**LEVY NUCLEAR PLANT, UNITS 1 AND 2  
DOCKET NOS. 52-029 AND 52-030  
SUPPLEMENT 4 TO RESPONSE TO REQUEST FOR ADDITIONAL INFORMATION LETTER  
NO. 085 RELATED TO SEISMIC SYSTEM ANALYSIS**

**Levy Nuclear Plant Units 1 and 2  
Supplement 4 to Response to NRC Request for Additional Information Letter No. 085  
Related to SRP Section 3.7.2 for the Combined License Application,  
Dated March 16, 2010**

**NRC RAI NUMBER:** 03.07.02-2

FIGURE RAI 03.07.02-02-1

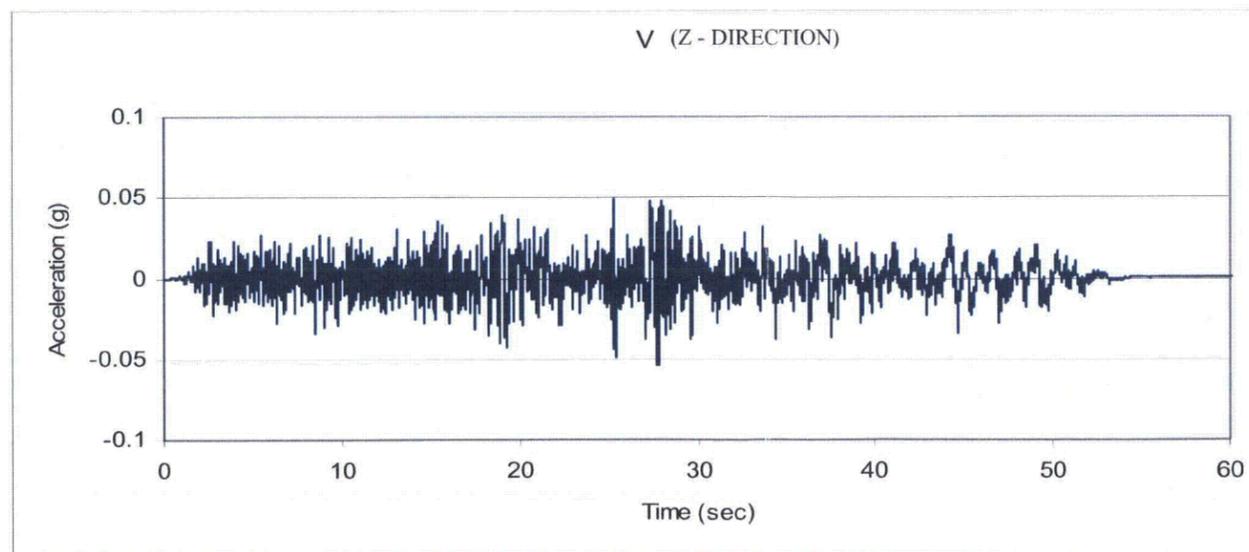
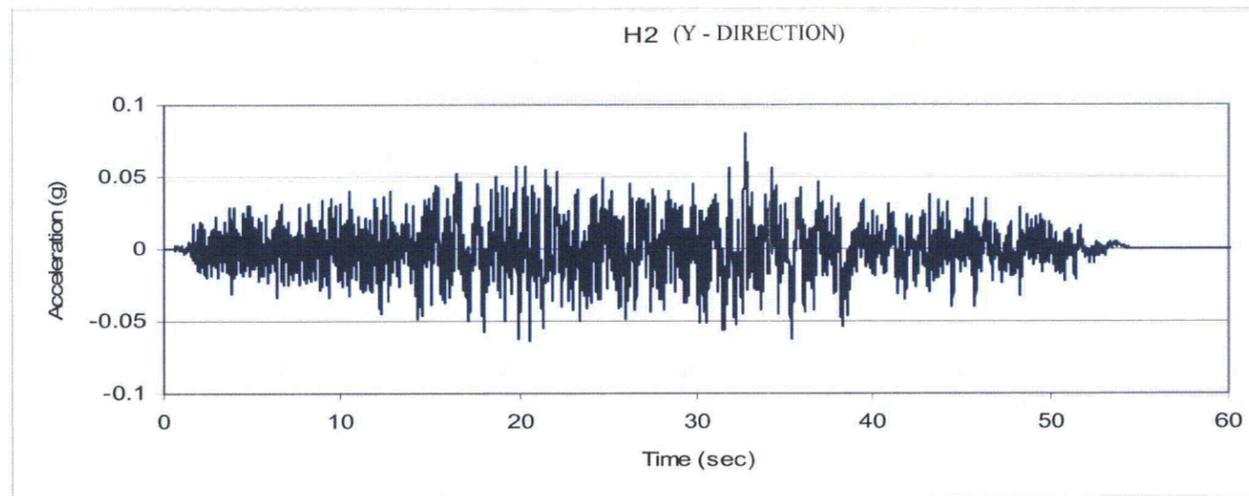
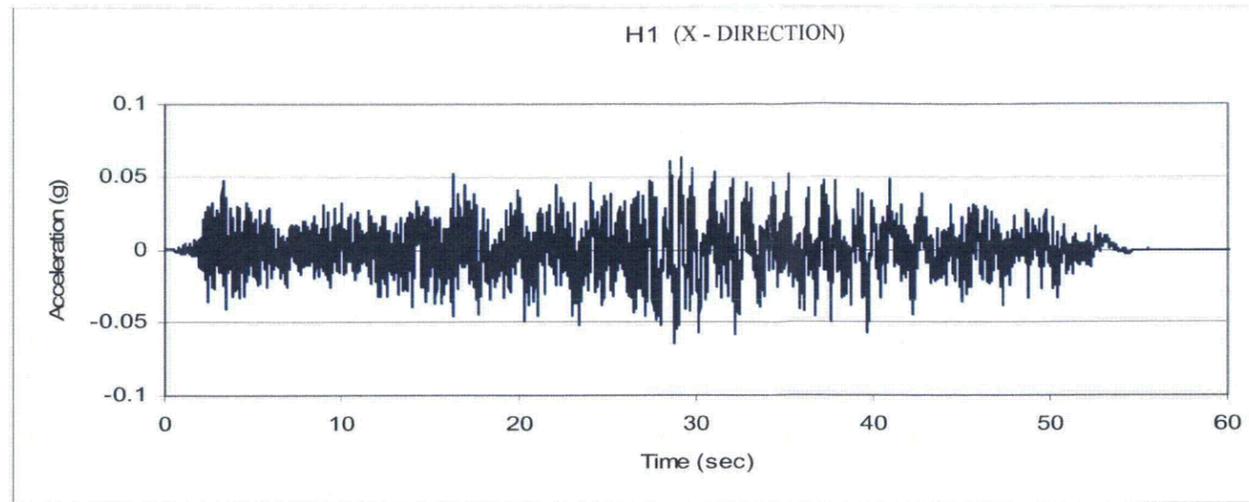
The applicant is requested to provide detailed site-specific seismic evaluation of NI structures and those surrounding structures that may impact the safety function of NI structures. The evaluation should fully incorporate the effects of soil-structure interaction and meet the Acceptance Criteria 4 of SRP Section 3.7.2. If such site-specific seismic evaluation will not be done, the applicant should provide technical justification for not doing so.

Input time histories for the SSI analysis were created in two steps. First, time histories were spectrally matched to the SCOR FIRS at the base of the planned excavation. Then these time histories were input into the four (UB, BE, LB, and LLB) free field soil columns (full height to elevation 15.5 m (51 ft.)) as outcropping motions and then output as in-column motion at the base of the excavation for use in the SSI analysis. As part of this process, the surface motion was computed for each of the four soil profiles and the SCOR FIRS was enhanced at intermediate frequencies to ensure that the surface motion envelops the PBSRS. The selected seed time history was the 1992 Landers Earthquake, Villa Park Serrano Ave station, chosen from the CEUS record library provided by NUREG/CR 6728. The seed time history was selected based on the seismological properties and spectral shape of both horizontal and vertical components. The selected time history represents a distance recording of a large (M 7.3) earthquake consistent with the dominant contribution to Levy site hazard by the Charleston source. Figures RAI 03.07.02-02-1 through RAI 03.07.02-02-4 show the in-column SSI input X, Y, and Z time histories at elevation -7.3 m (-24 ft.) for the Best Estimate (BE), Upper Bound (UB), Lower Bound (LB), and the Lower Lower Bound (LLB) Soil profiles respectively.
